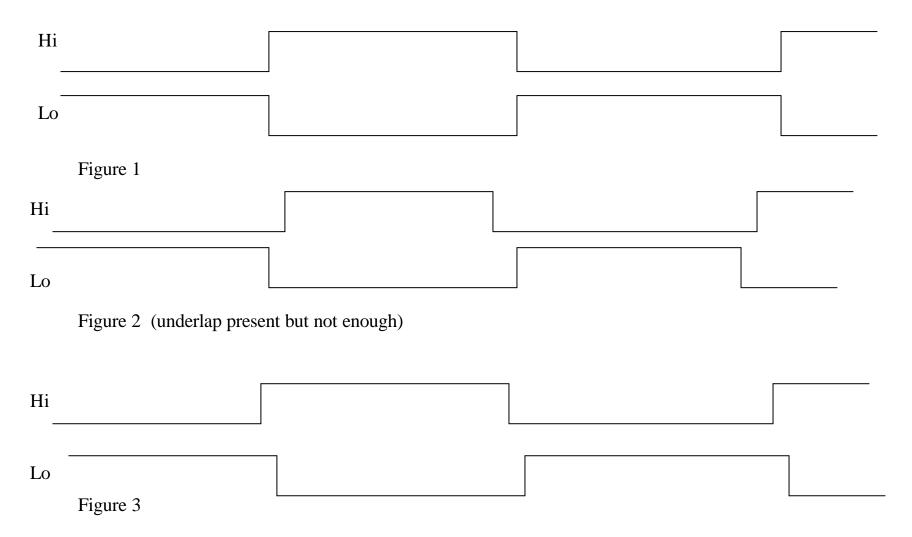
Are the outputs from the PIC like Figure 1, 2 or 3?

I have exaggerated the overlap/underlap for clarity.

If Fig 1 or 2 apply, make 2 of these and insert in the Hi and Lo lines between the PIC and the IR2181 ICs.

If Fig 3 applies, make 1 of these and insert it in the Hi line between the PIC and the IR2181 ICs. If more underlap is required in the Lo line, insert 1 in this line also.

These will delay the positive edges of the signals by about 1 uS but only delay the negative edges by about 100 nS.

Connect the unused inputs of IC1 to gnd.

If 1 uS is insufficient, increase C1
